Appendix I: Comments regarding the information submitted as part of the application for renewal and variation of IP 0001/06/B dated April 2019.

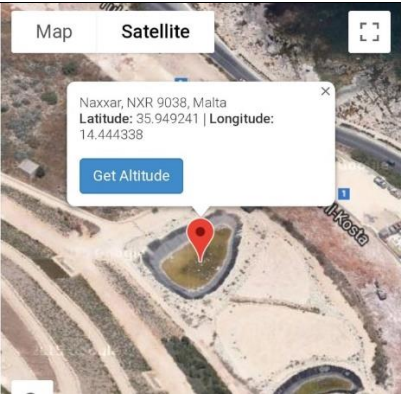
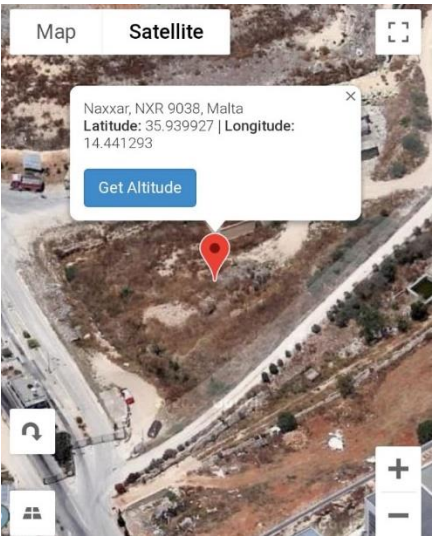
12.	<p>With reference to Para "6.2 Surface Water Treatment and Disposal", applicant is to provide the geo-reference coordinates on an updated layout plan of such discharge point.</p>	<p>Surface water is currently being monitored on a quarterly and annual basis as specified in the EMP (Dec 2014). In the new consolidated EMP draft sent to ERA in August 2018 it was suggested that in the absence of adequate surface water features, this monitoring should be discontinued. ERA had no comments regarding this however following internal discussions a new proposal shall be sent to ERA as summarised below:</p> <ul style="list-style-type: none"> Ghallis – quarterly and annual sampling from the silt pond (to point out that in this case surface runoff would be collected from Maghtab as well) 	<p>Noted.</p> <p>Kindly note that the submitted "Maghtab site plan" in Annex 12 indicates 3 silt ponds at Ghallis which are not included in the EMP or in IP/01/06/B. Applicant is thus to provide the geo-reference coordinates of each such silt point, include its monitoring in a revised EMP and provide details on how it is constructed in such a way to prevent potentially contaminated effluent from contaminating the surrounding environment.</p>	<p>/</p> <p>Only 1 slit pond is of interest. The other 2 silt ponds collect run-off mainly from the old Maghtab dump. That is why, Wasteserv is proposing the use of the indicated silt pond.</p> <p>Reference to the silt ponds, please refer to Annex / folder titled Plans.</p>
